HEADQUARTERS
UNITED STATES CONTINENTAL ARMY COMMAND
FORT MONROE, VIRGINIA

SUBJECT: Report of Project Nr 2922, Evaluation of Modified Feed System
for Gun, Machine, 7.62mm, M60

UNITED STATES ARMY INFANTRY BOARD
Fort Benning, Georgia

SUBJECT: Report of Project Nr 2922, Evaluation of Modified Feed System
for Gun, Machine, 7.62mm, M60

Incl 1

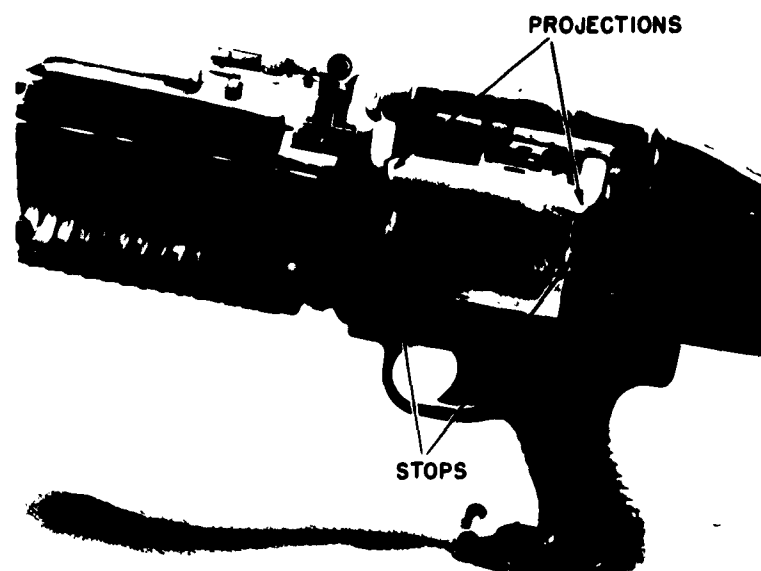
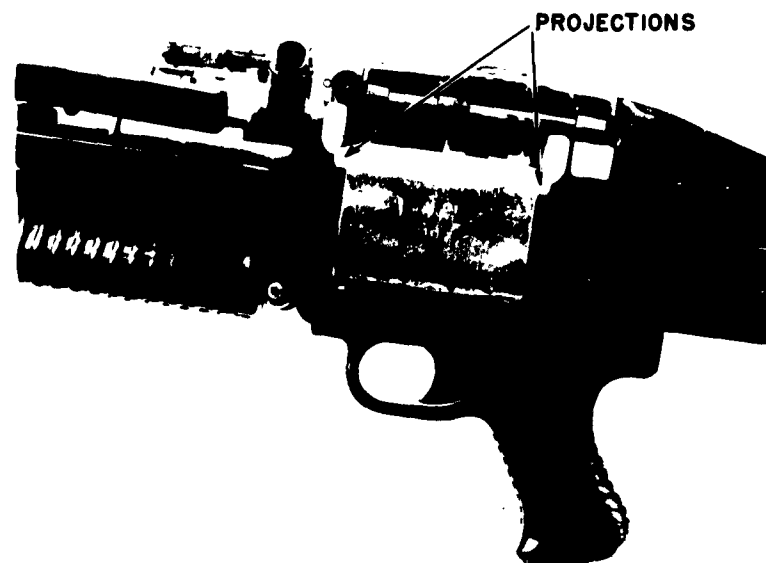
d. The Type B test item was more satisfactory than the Type A test item for hip and shoulder firing. The stops on the Type B test item prevented the bandoleer from interfering with the manipulation of the trigger. However, in this role there was no significant difference between either test item and the control item.

e. There was no difference between the capabilities of the Type A or Type B test items and the control item to retain a 100-round bandoleer when the gun was carried by a walking soldier. However, when the soldier ran, jumped, crawled and then changed the carrying position of the gun with the bandoleer attached, the bandoleer frequently came off the Type B test item. This seldom happened with the Type A test item and the control item.

b. The Type B Modified Feed System for the Gun, Machine, 7.62mm, M60, is not suitable for use with the Gun, Machine, 7.62mm, M60.

a. No further consideration be given to the Type B Modified Feed System.
